**BEAR VET CEMETERY EXPANSION  
BEAR, DELAWARE  
DBF #0586B065.B01 ❖ OMB/DFM #MJ2009000008  
FEBRUARY 26, 2026**

**ADDENDUM NO. 4**

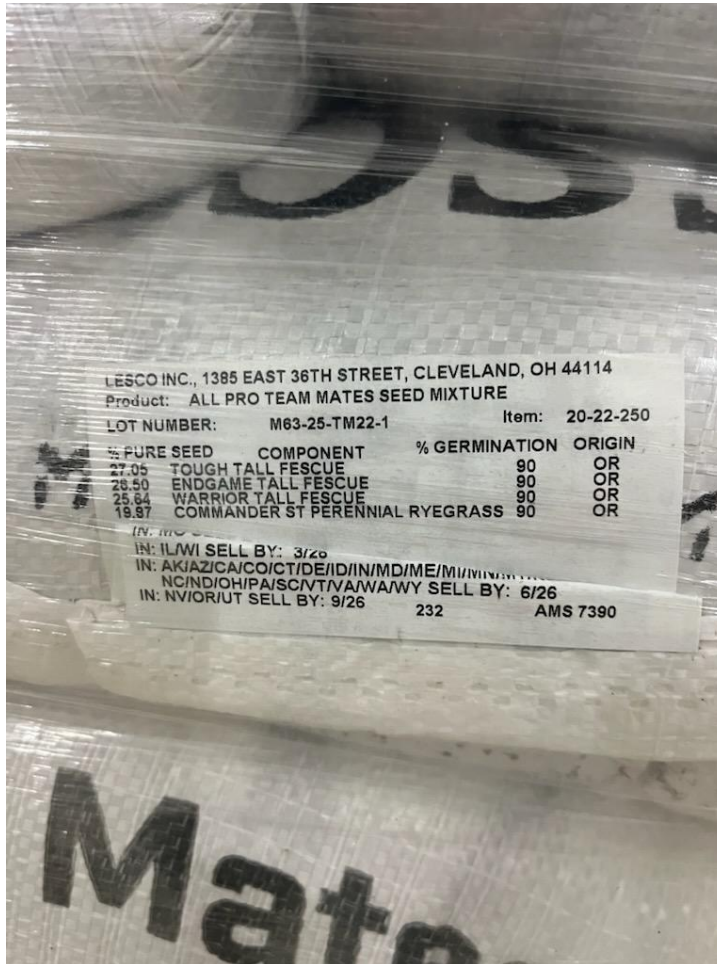
69. **For seed mix see photo on next page.**
